MILITARY SPECIFICATION

TRANSCEIVER: 10540501

This amendment forms a part of Military Specification MIL-T-60500A(MU), dated 22 September 1970.

FIGURE 3

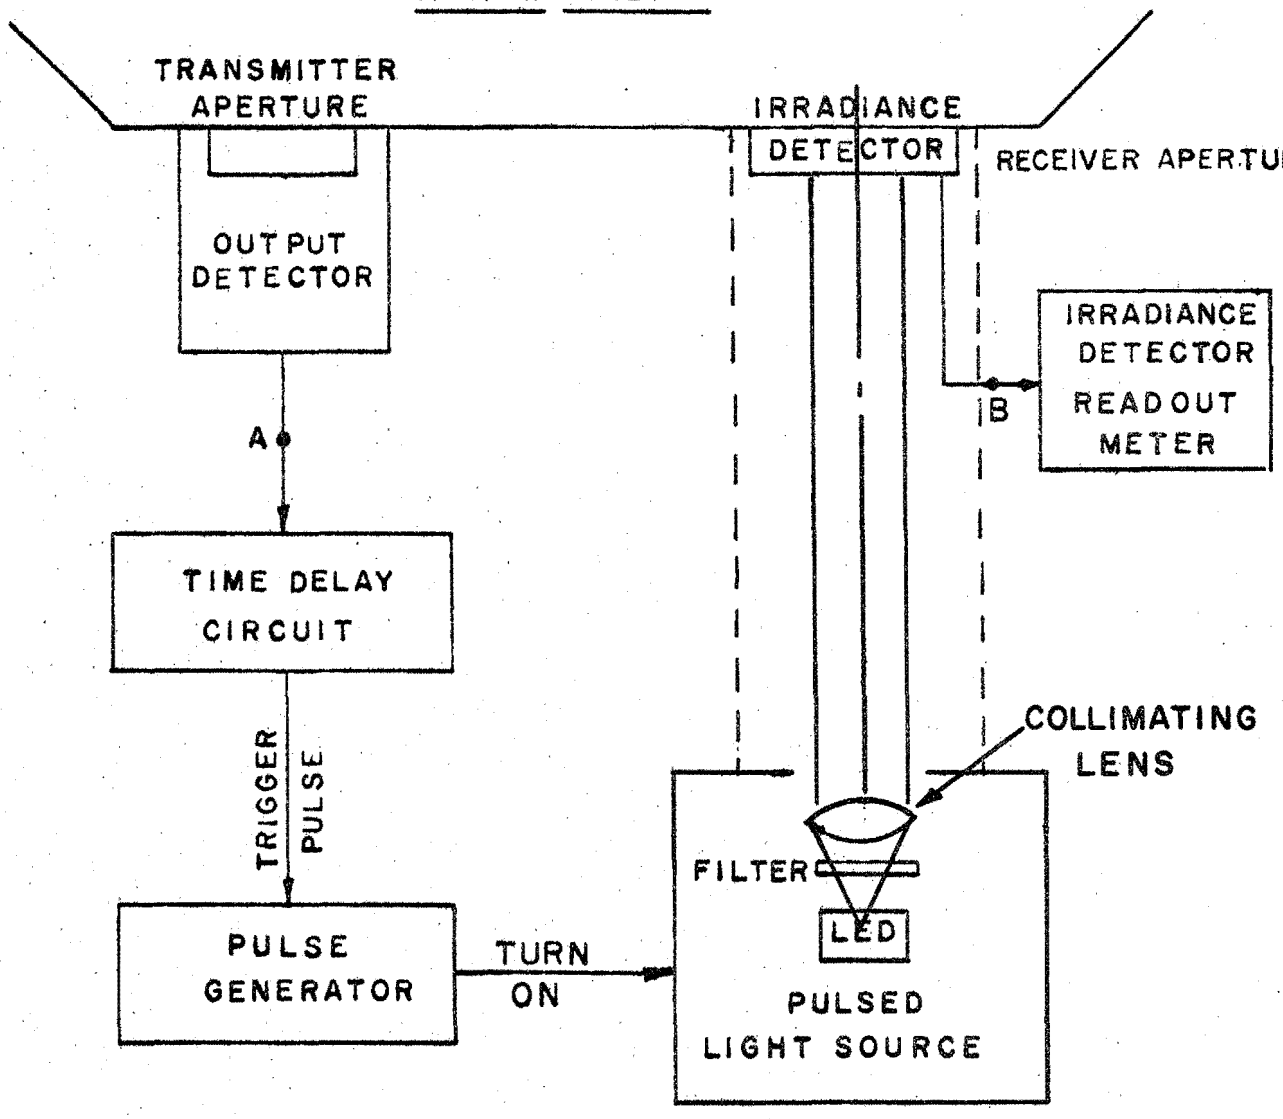
* Figure 3: Delete and substitute attached Figure 3.

NOTE: * 1. MEASURE TIME DELAY FROM POINT "A" FROM OUTPUT DETECTOI TO POINT "B" FROM IRRADIANCE DETECTOR.

2. ISOLATE THE RECEIVER APERTURE TO PREVENT ERRONEOUS READINGS FROM REFLECTIONS FROM OUTPUT PULSE.
